**REZONING, PUD &  
SUBDIVISION STAFF REPORT**

**Date: December 4, 2008**

Pinehurst, Delany's Addition to Springhill, Block 10, Resubdivision of and Addition to Lots 9, 10, and 11

# SITE PLAN

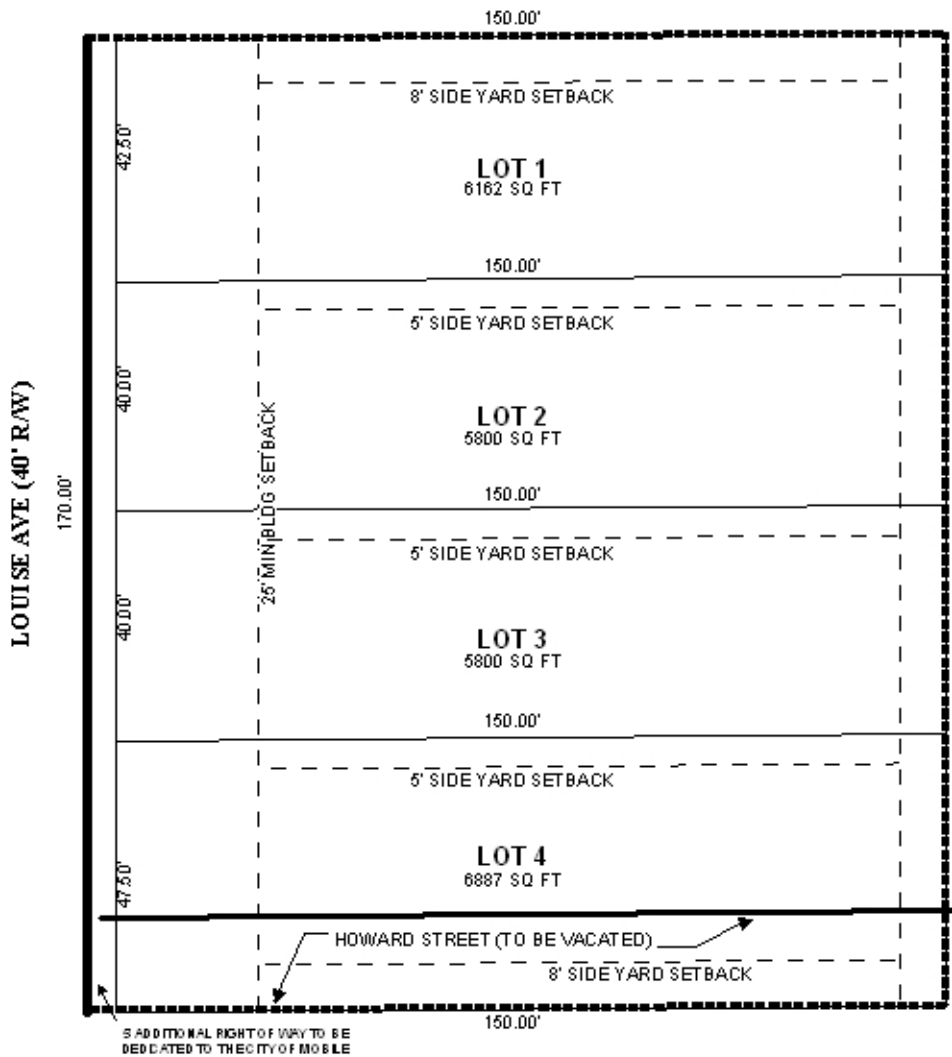
As illustrated on the plat, the applicant has requested reduced side yard setbacks. The applicant has also requested maximum site coverage of 40%, though it isn't depicted on the plat. The plat and site plan should be revised to clearly label the maximum site coverage of 40%, in addition to the required setbacks for each lot.

It should be noted that while the subdivision is proposed as a zero-lot line subdivision, any air conditioning unit over 3' in height will still be required to meet the setbacks.
